**RE: Request for Additional Information - Completeness of Application  
Expedited Land Division -- ELD-26-03**

# Expedited Land Division for 2-Parcel Partition

**4110 Cornwall Street, West Linn  
Tax Map 21E36BA, Tax Lot 6100**

DRAWING NAME: J:\3077-004\26\6. ENGINEERING\3. CAD\PRODUCTION\1. LU\3077-004. C201.DWG - 2026/04/24 - 03:18PM - JDM

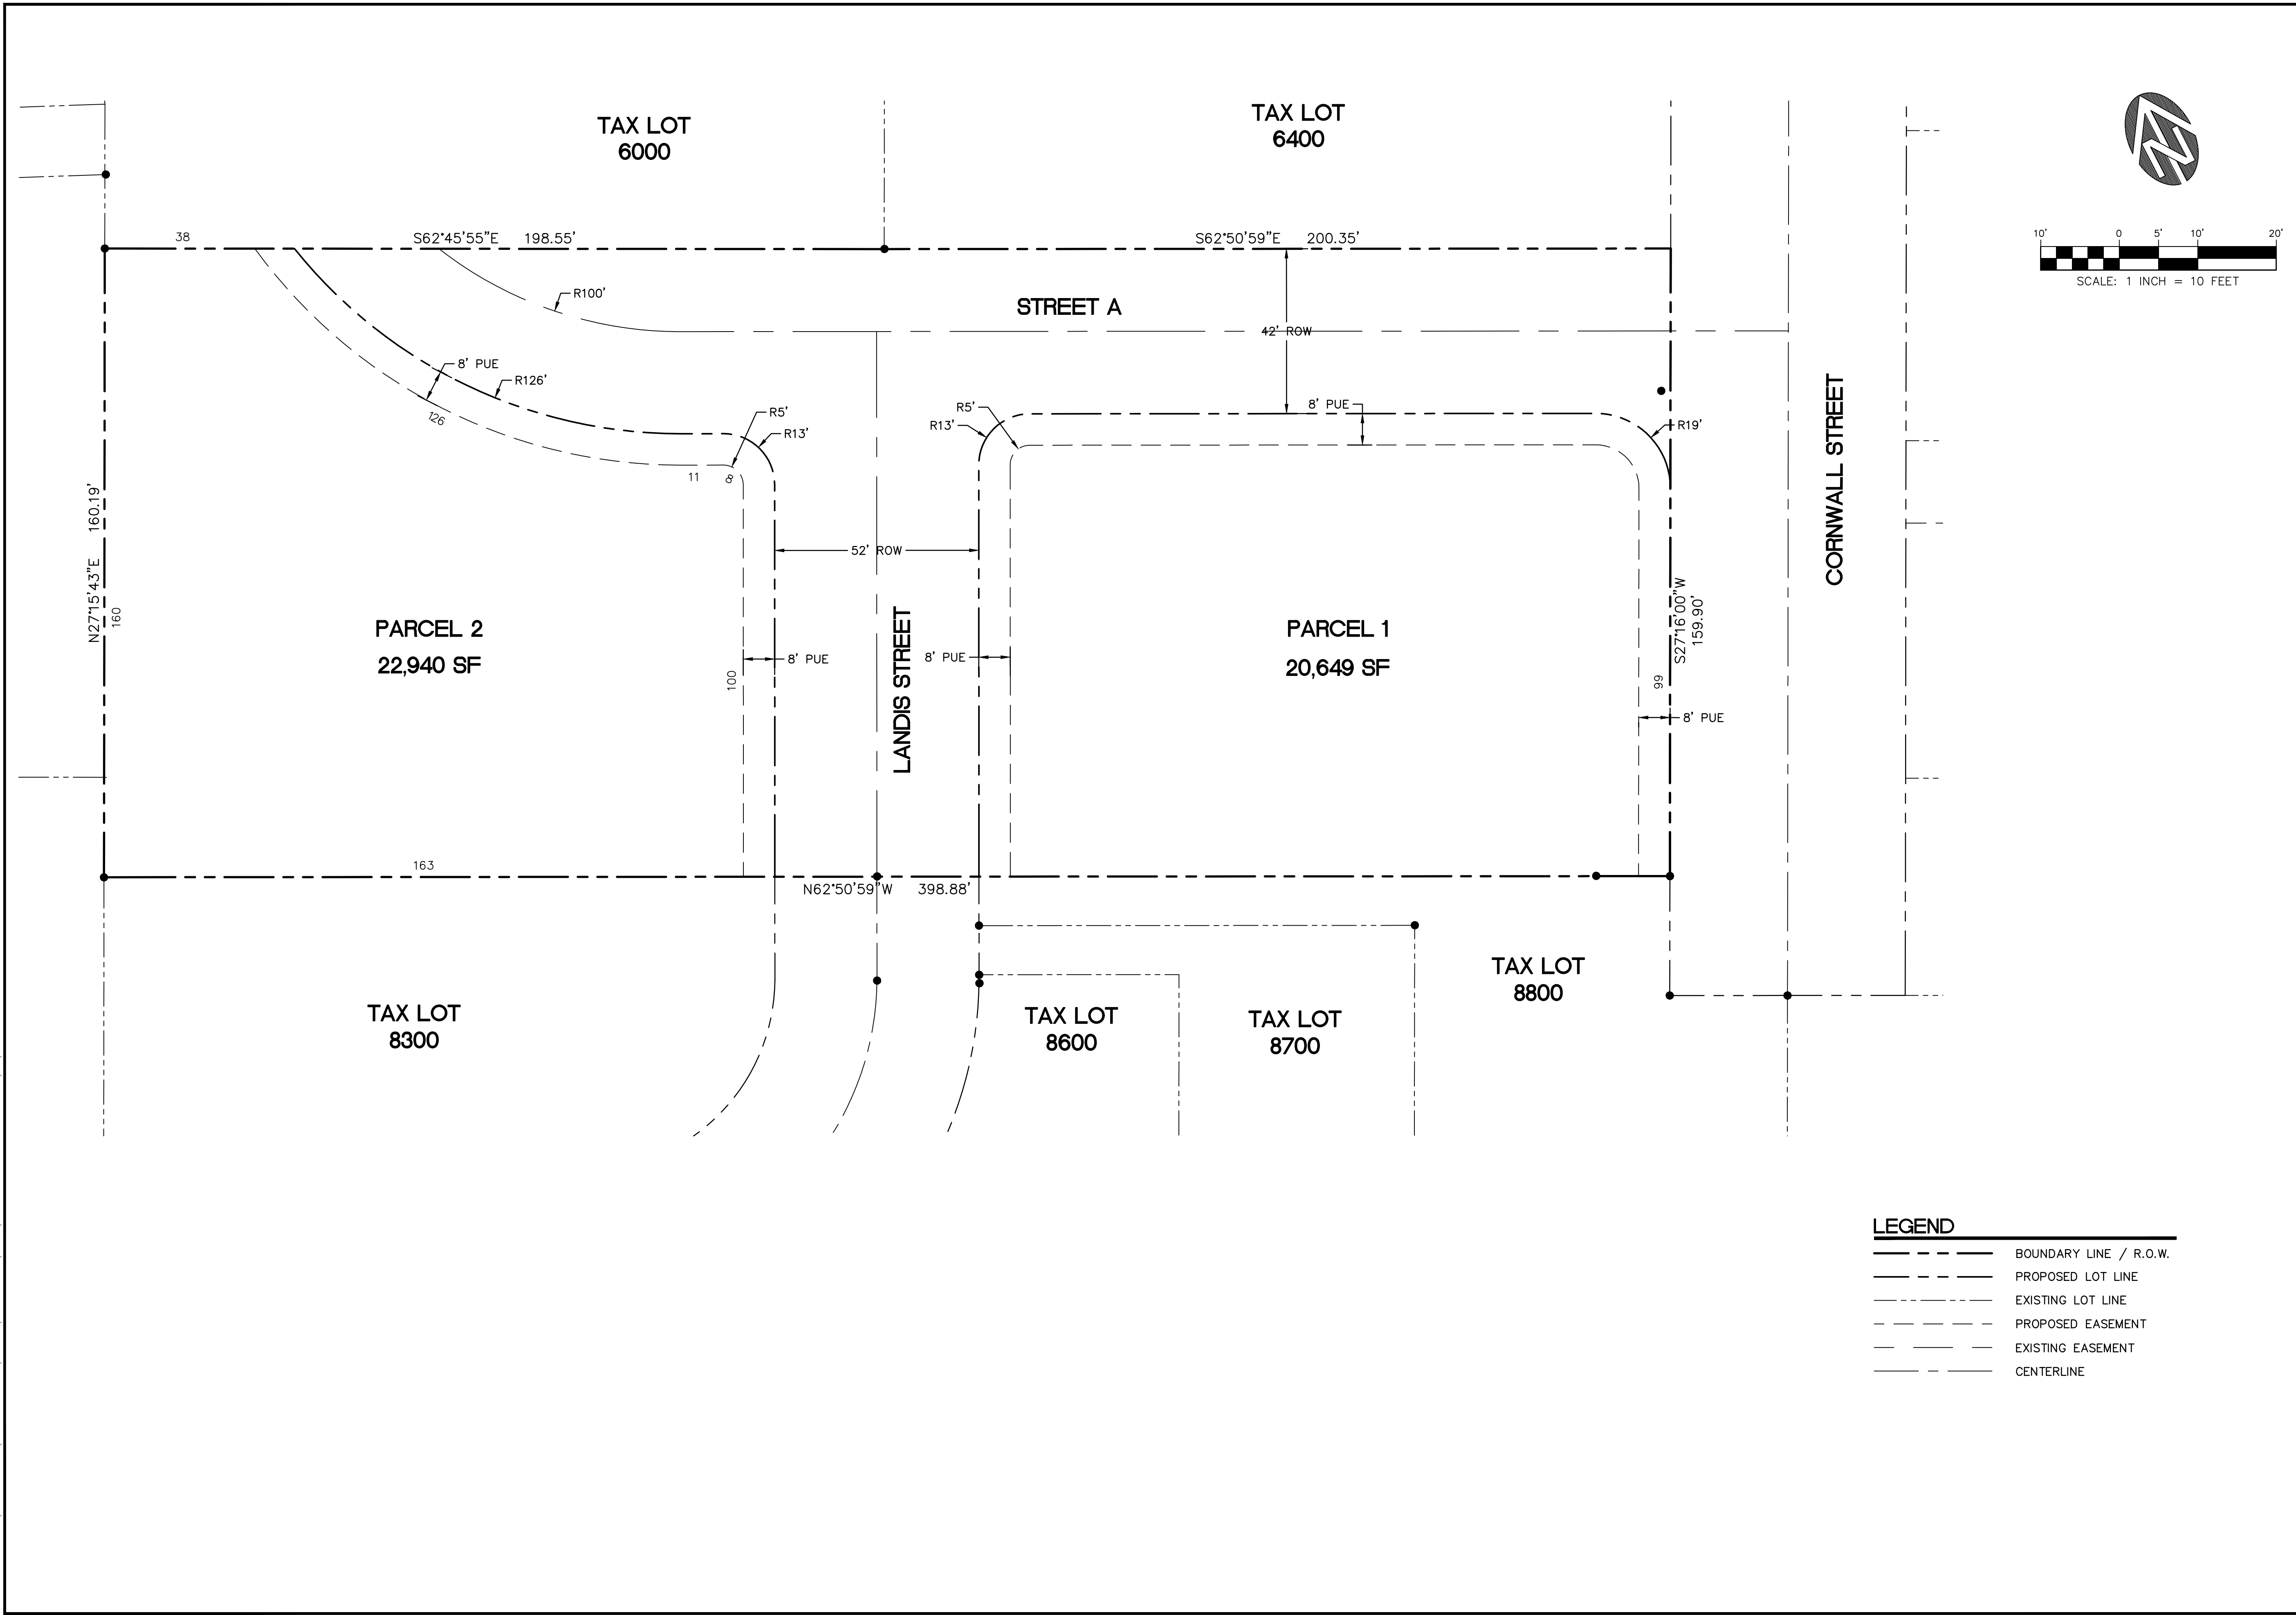
2. *Preliminary Plat (Sheet C201)*
  - a. *An 8-foot wide PUE is required along the site's Cornwall Street Frontage.*

**RESPONSE: Sheet C201 of the Preliminary Engineering Plan Set, Exhibit B, has been updated to show the 8' PUE along Cornwall Street frontage of Parcel 1.**

SHEET  
**C300**  
 JOB NO.  
 3077-004

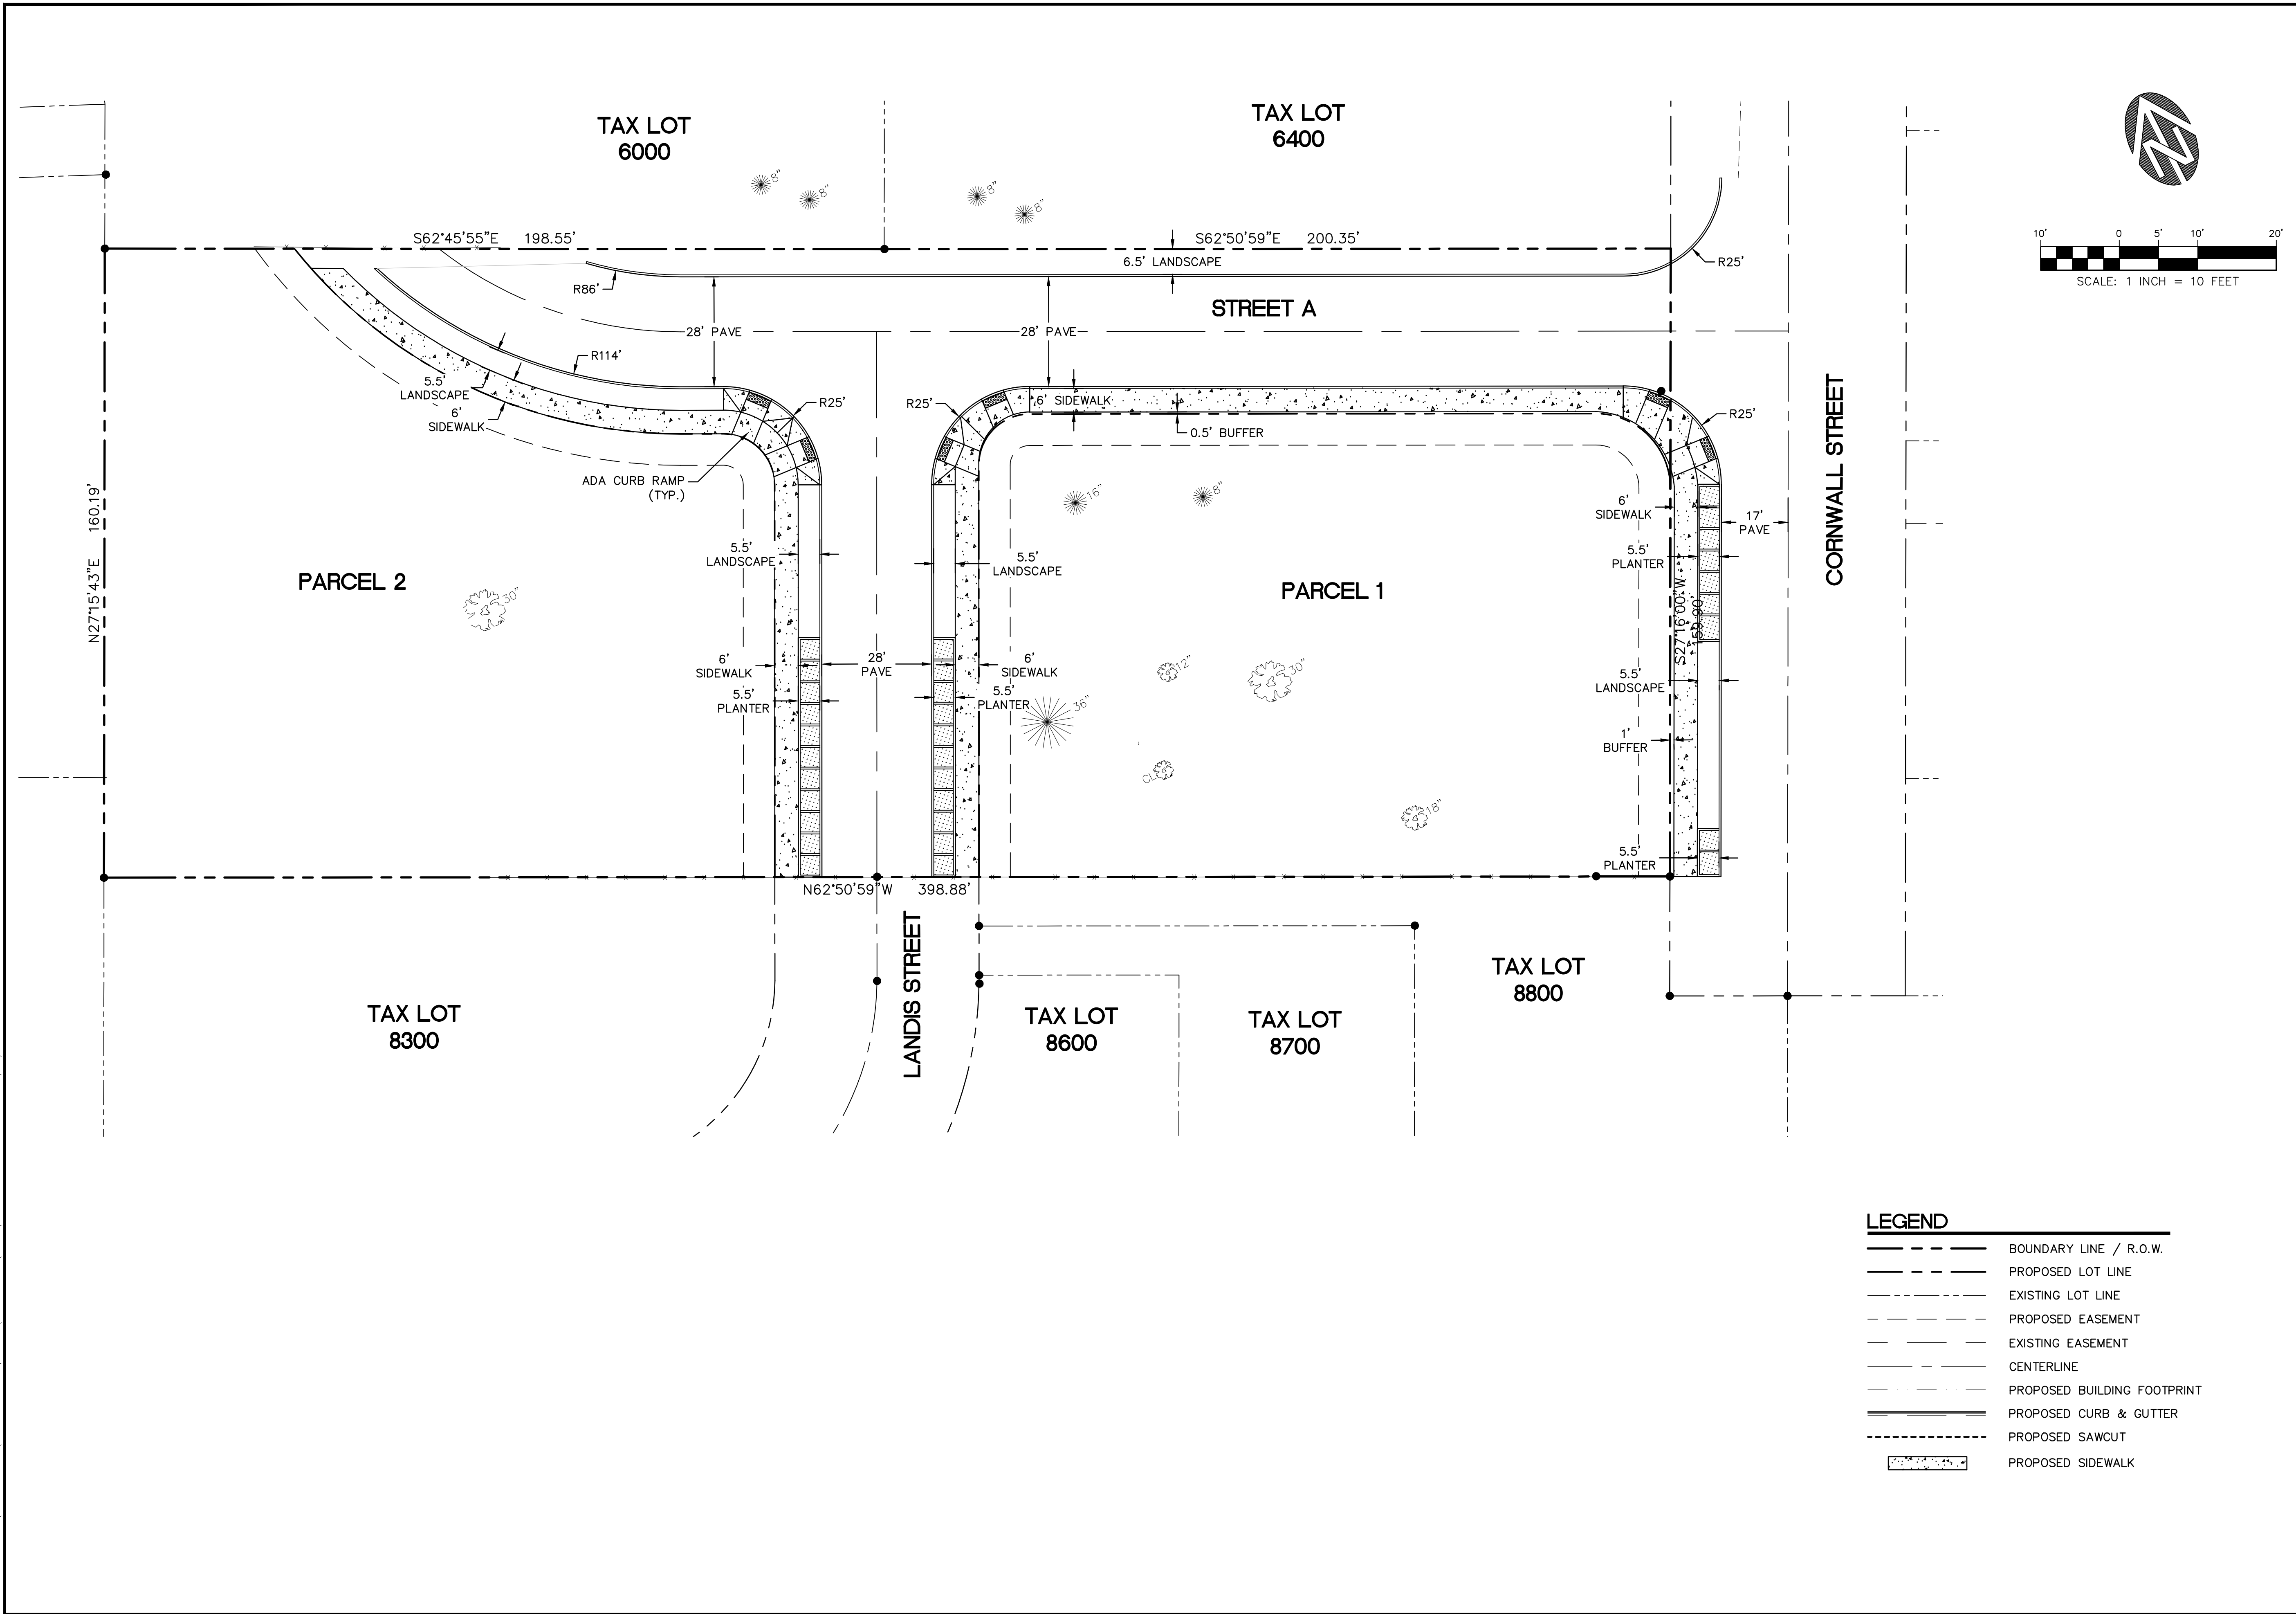
3. *Site Plan (Sheet C300)*
  - a. *Curblin must align with curblin at 4190 Cornwall Street.*
  - b. *ADA ramps are required at all street corners and crossings.*

**RESPONSE: Sheet C300 of Exhibit B has been updated to illustrate the Cornwall frontage curblin aligned with existing curblines, and ADA ramps at street corners and crossings.**

DRAWING NAME: J:\3077-004\26\6. ENGINEERING\3. CAD\PRODUCTION\1. LU\3077-004. C500.DWG 2026/04/24 - 03:17PM - JDM

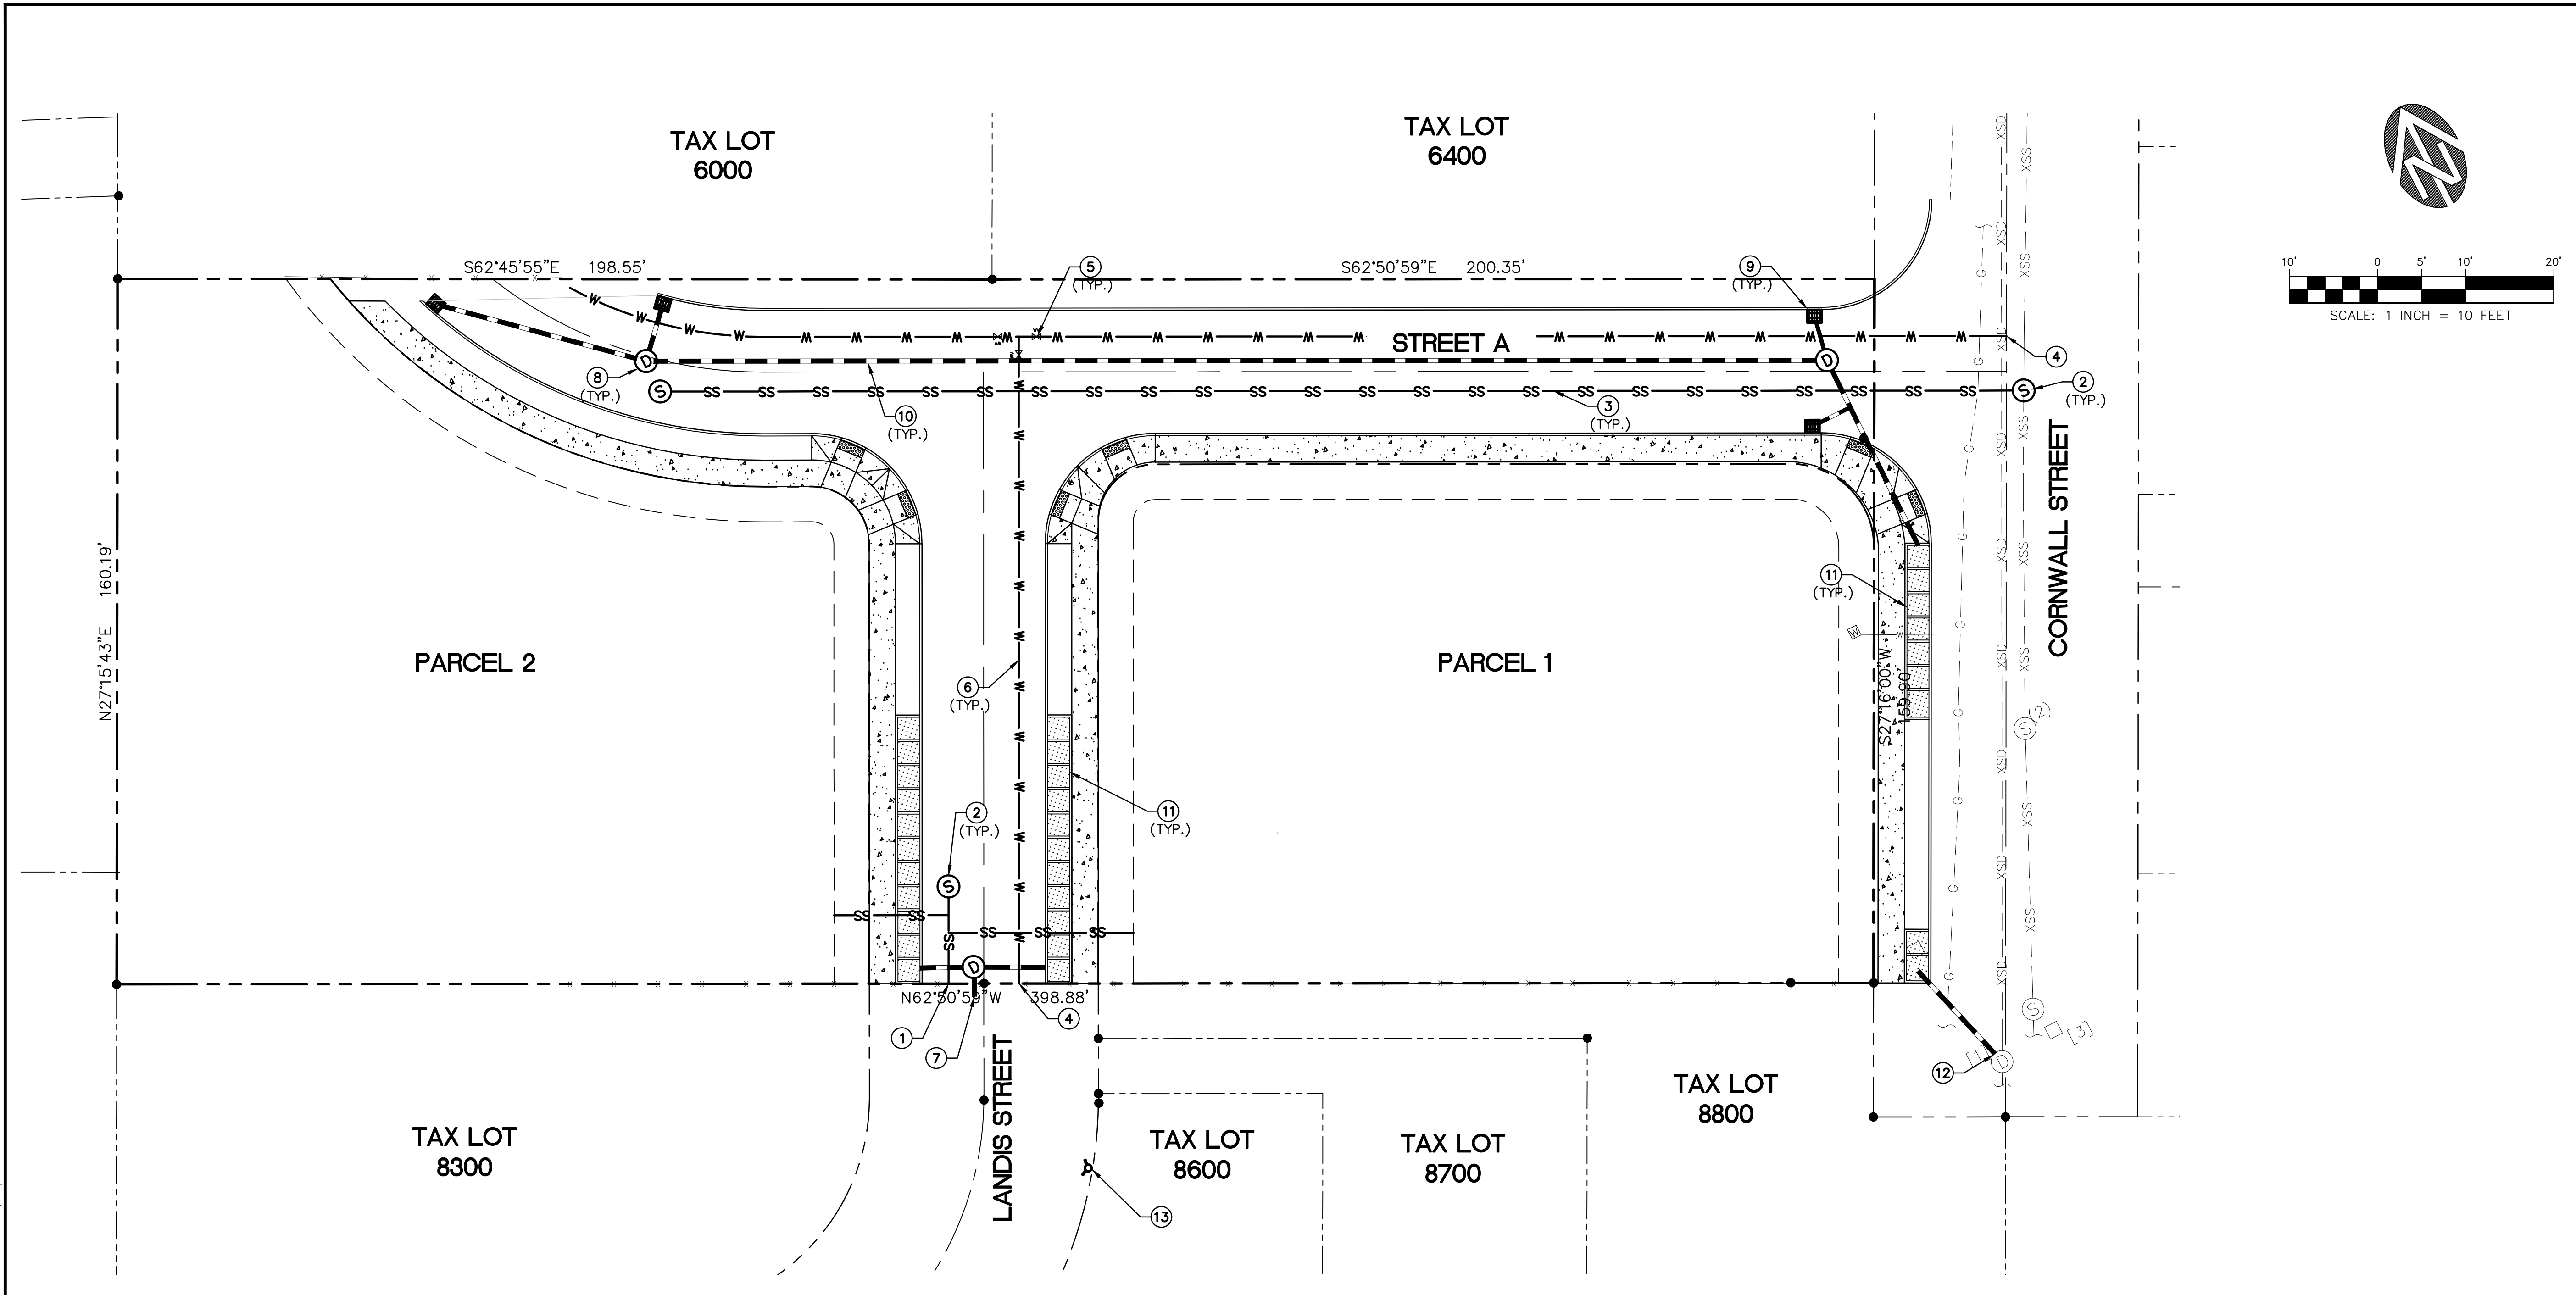
4. *Composite Utility Plan (Sheet C500)*

- a. *If further land division is anticipated, extension of sewer main may be needed.*
- b. *A fire hydrant is needed to meet 400-foot spacing standard for residential areas (Design Standards 4.0032).*

**RESPONSE: The sanitary sewer main located within Landis Street has been extended as shown in the updated Sheet C500. As illustrated on C500, an existing fire hydrant on Landis south of the subject site meets the 400-foot spacing standard.**
